# PLANNING REPORT

**Report Number:** COU25-028

**Title:** Statutory Public Meeting Report with respect to Application for Draft Plan of Subdivision 31T24-002 and Zone Change Application Z07-24

### Proposed Draft Plan of Subdivision

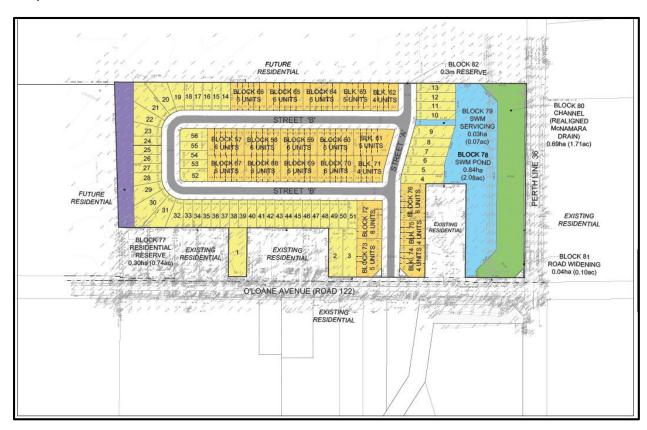
- Sanitary Servicing
    - An additional straight through maintenance hole with similar upstream and downstream sloped sewers shall be provided between the proposed subdivision and future O'Loane sewer for the purposes of flow monitoring.

- Municipal Water Distribution
    - The O'Loane Avenue watermain is to extend from Lot 1 to terminus point to the south.
    - A watermain on Perth Line 36 is not required.

- A temporary connection to O'Loane Avenue is required to loop the system until the watermain on Street A can be connected to the adjacent subdivision commissioned system. Building permits will not be issued until the watermain is properly looped.

- Storm Sewer Servicing
    - The rear-yard system that outlets to O'Loane Avenue must be to the proposed F. MHA21. If this system is not available, then the developer is to install the maintenance hole, required pipe and headwall.

- Rear yard catch basins will not be accepted between Streets B & C.
    - Rear yard catch basins will be accepted behind lots 62 to 66. The grade
      of this lot line shall be coordinated with the adjacent developer and
      temporary measures may be used.

- Roadworks
    - A temporary access road to O'Loane Avenue is required until Street A is connected to the adjacent development and has an exit to either Perth Line 36 or O'Loane Avenue.

A sidewalk is required across the O'Loane Avenue frontage.
